RFI #: 109
 Date: 4/16/2012
 Job: EB-02 Keller Springs Lofts
 Phone: 877-777-5115

CC: Trent Perkins (Parkin Perkins Olsen), Enviro Design Landscape
 Subject: Elevation Discrepancies

Keller Springs Lofts
 EMBREY PARTNERS, LTD
 ADDISON, TEXAS

Drawing: A3, C, 2C & S2.13
 Cost Impact: None

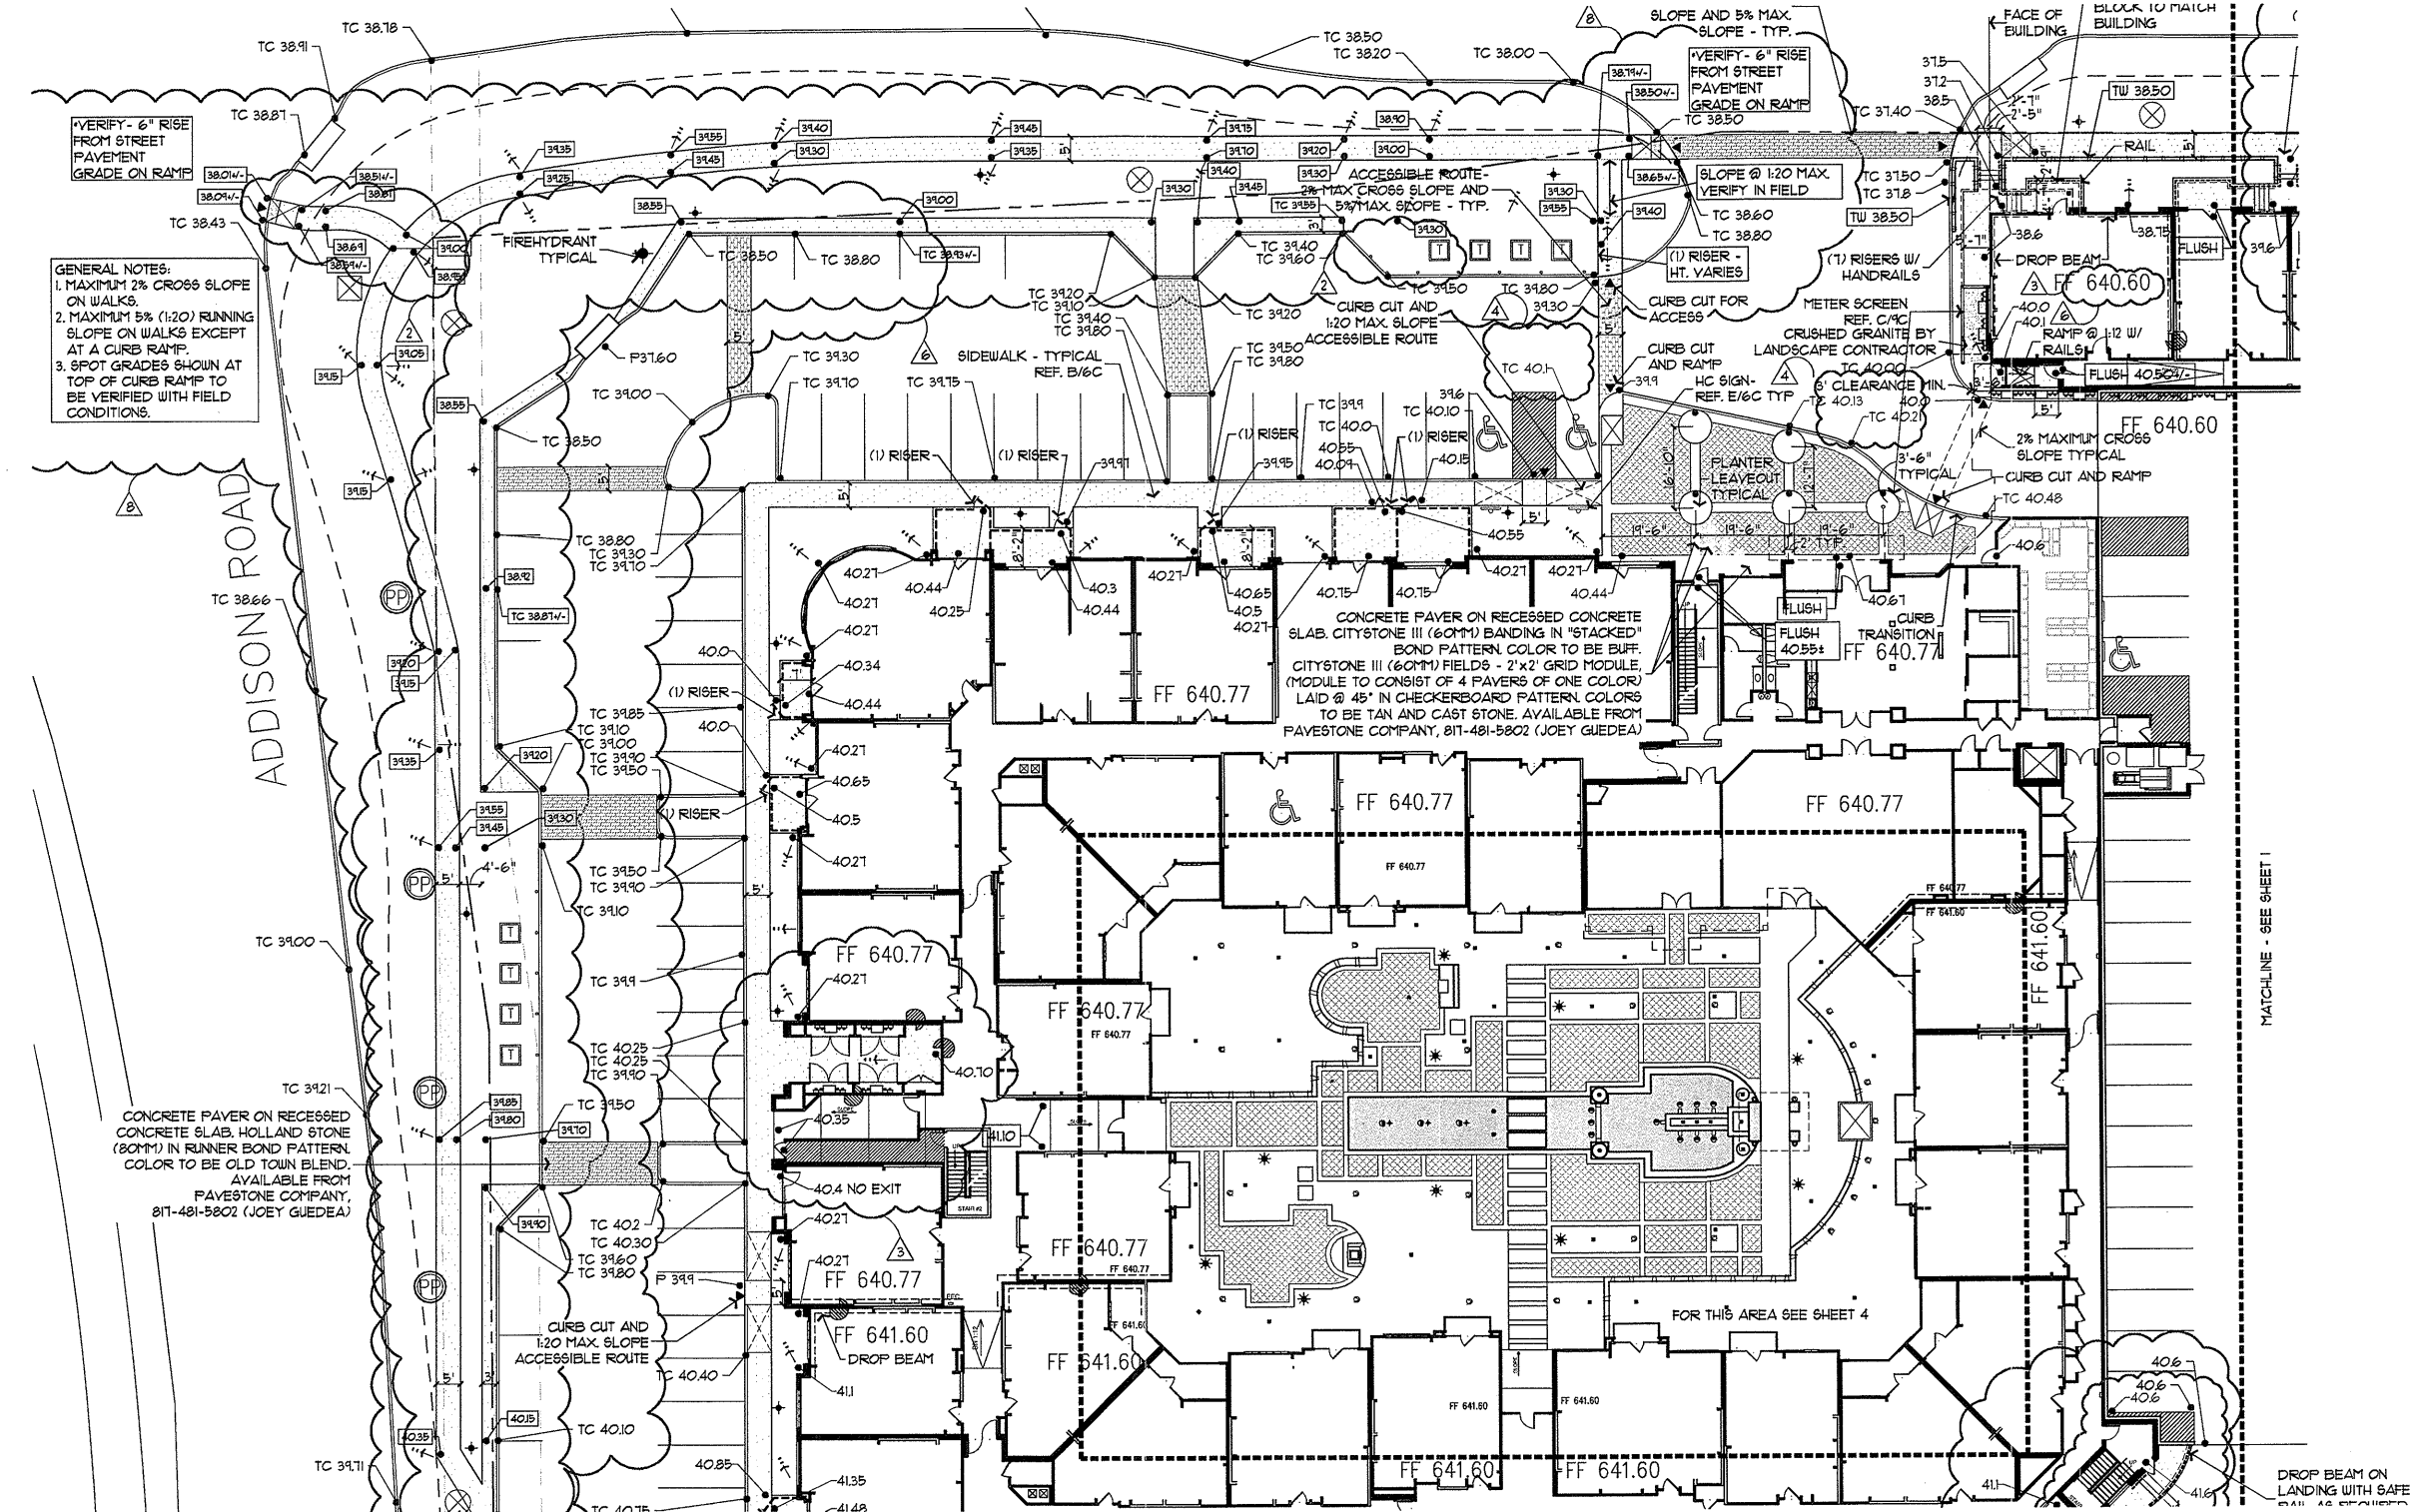
Request: Date Required: 4/20/2012
 Architectural and Structural plans show FF at 640.6'. Landscape shows 641.6. Please confirm the correct elevation is 640.6'.
 Architectural shows a spot elevation outside the building at 640.5'. Landscape shows a spot elevation of 640.1' at the bottom of the ramp and 640' in the street just outside. Please confirm the correct spot elevations.

* THE CORRECT FINISH FLOOR ELEVATION IS 640.60. WE WILL UPDATE OUR DRAWINGS. SPOT ELEVATION ADJACENT TO EXTERIOR OF UNIT AREA CORRECT AS SHOWN.
 * THE SPOT ELEVATION AT THE BOTTOM OF RAMP SHOULD BE 640.0, AND THE LANDING AREA AT THE BOTTOM OF RAMP CAN NOT BE 640.0 CROSS SECTION.
